Sheet: /  
 File: MPPT Charge Controller.kicad\_sch

**Title: MEGAPHONE MPPT Charge Controller**

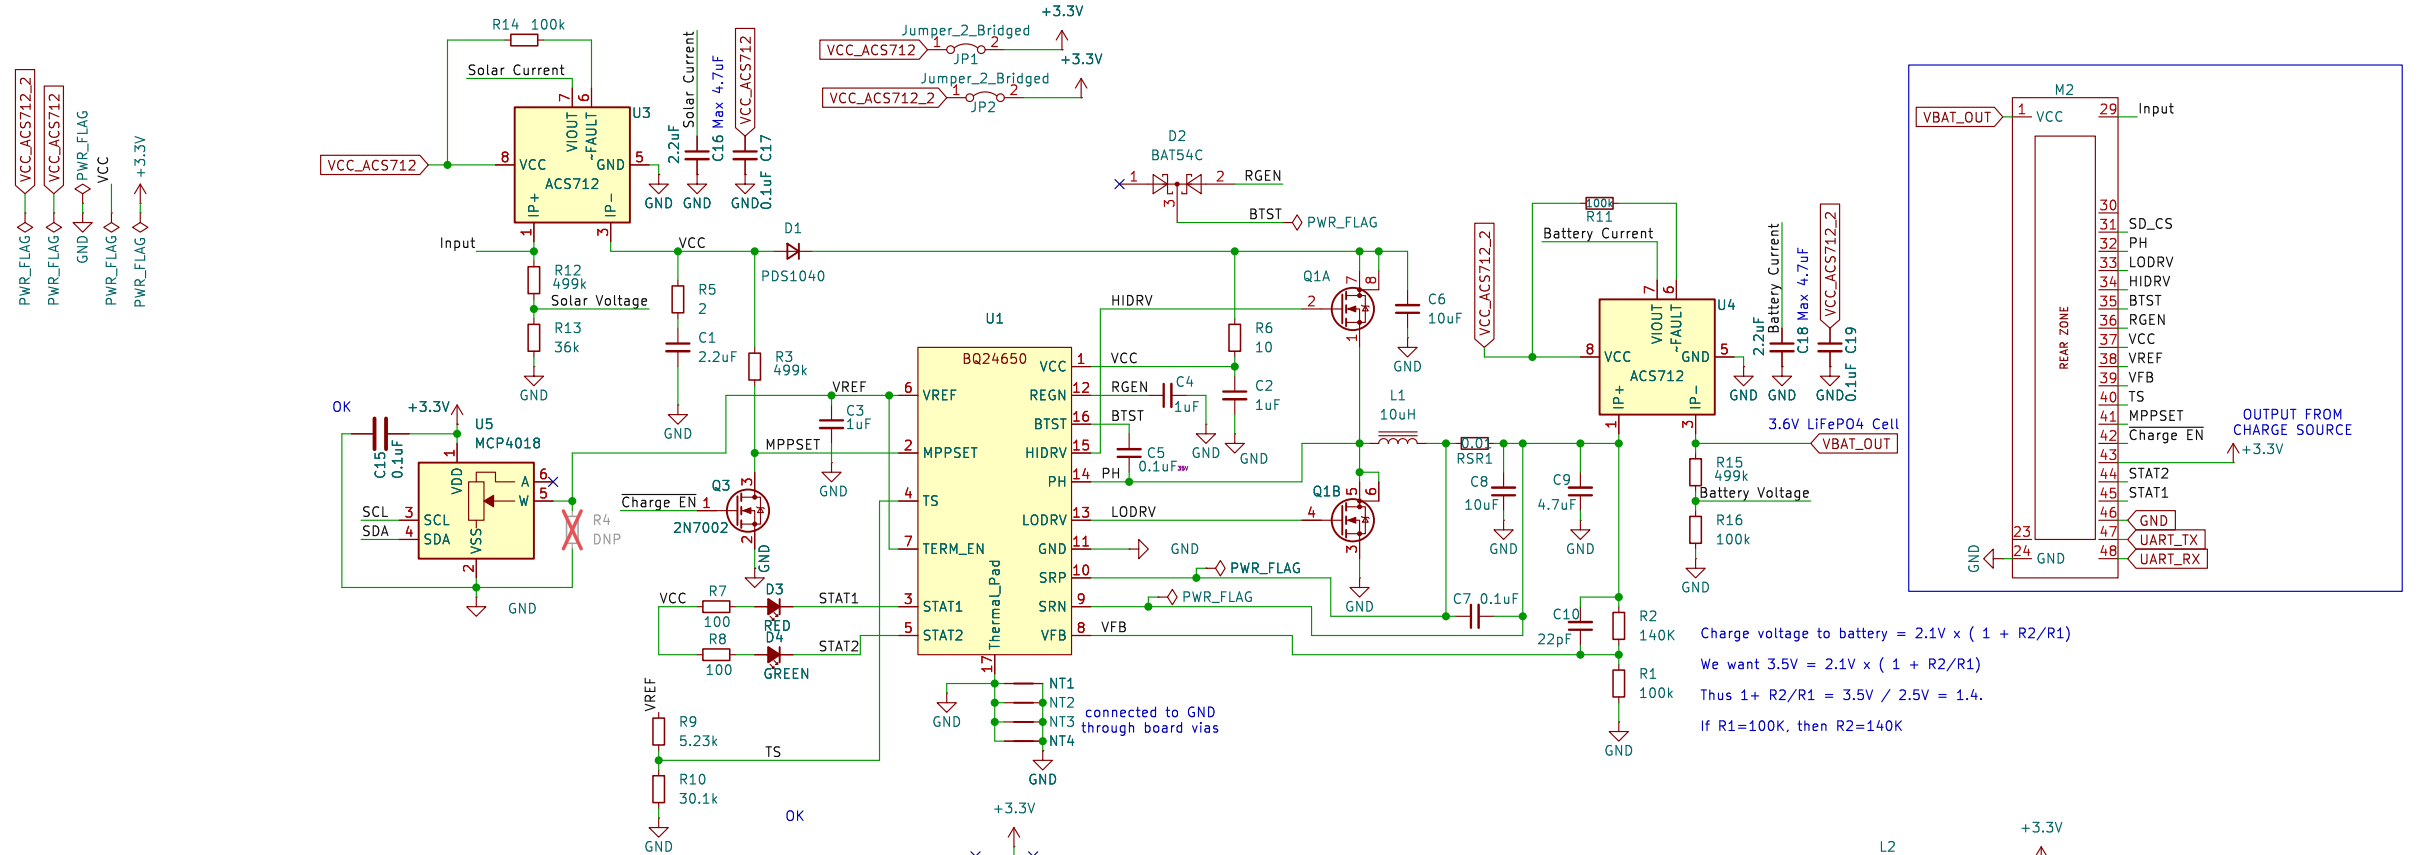
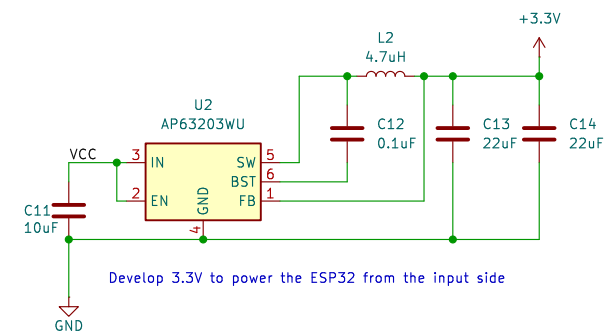
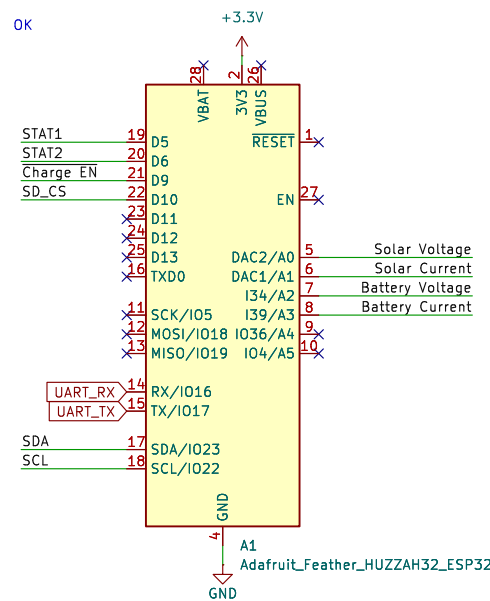
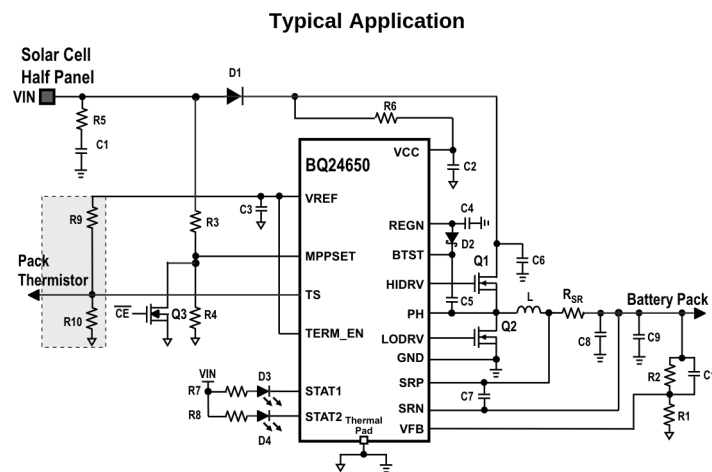
ACS712 Actually requires VCC = 5V, not 3.3V according to datasheet?

People on the internet indicate that they seem to work fairly fine on VCC=3.3V, though.

RSR1 sets max charge current:  
 $I_{MAX} = 40\text{mOhms} / RSR1$

20mOhms thus limits to 2A

ACS712 on VCC=5V will have output on VIOUT to 3.3V ADC below 3.3V upto about 4A, or 7A if the 20A version of the ACS712 is used.

Thus we can use 10mOhms to allow upto 4A charging. With a 10Ah LiFePO4 is his 0.4C, which is below the save limit of 1.0C

Adapted for 3.5V output voltage  
 Adapted for MEGAPHONE module format

There is 3.3V version so we should use that one!
